SUBSURFACE WASTEWATER DISPOSAL SYSTEM APPLICATION

City, Town, or Plantation: **AUGUSTA**
Street or Road: **115 WOODARD ROAD**
Subdivision, Lot #: **M69/L10**

Subject: Approval, Replacement System Variance Request, Tom Colfer Property, 115 Woodard Road, Augusta, Maine. Mailing Address Owner/Applicant: 1 Serenity Drive, West Gardiner, Maine, 04345.

SUBSURFACE WASTEWATER DISPOSAL PLAN

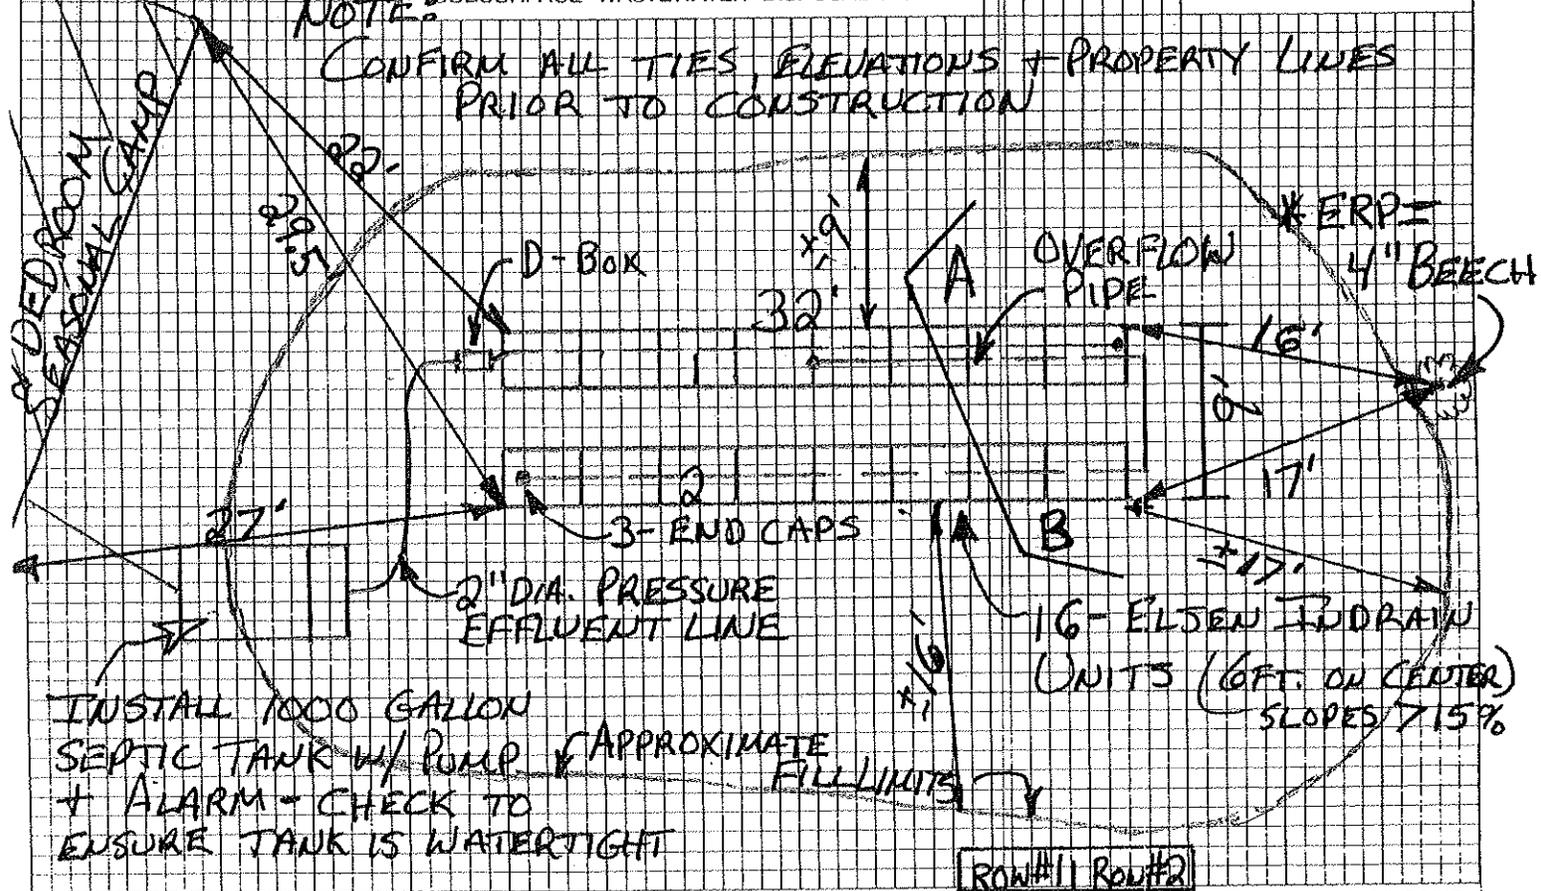
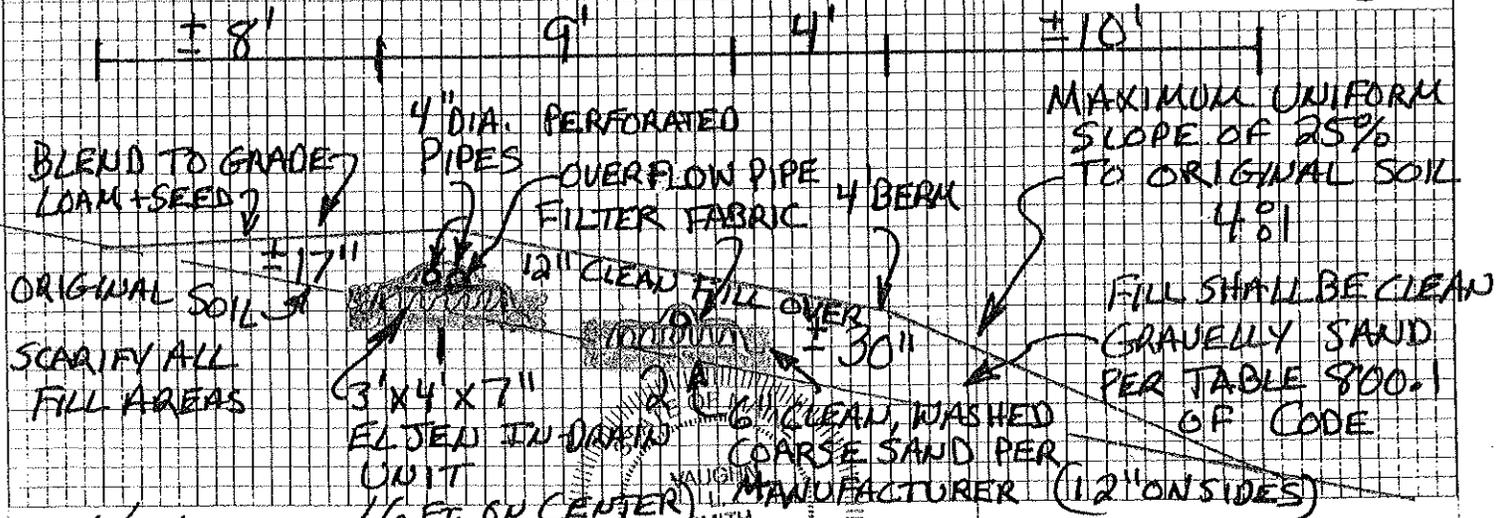
The variance request that is not within the LPI's authority is from the disposal field to a major water course of 40 feet.

The variance request that is within the LPI's authority is from the septic tank to a major water course of 25 feet.

The variance request has been submitted because topography and existing development limit the potential of the system location and the system design prepared by Vaughn Smith, SE #226 on 05-12-2014 is otherwise found to be in compliance with the Maine Subsurface Wastewater Disposal Rules.

The system is to be installed in accordance with the submitted and approved system design. Should alterations to the design be required at the time of construction, the site evaluator is to be notified prior to making any changes.

The contractor is to scarify the soils under the fill extensions to create a transitional zone more compatible with the disposal field area.
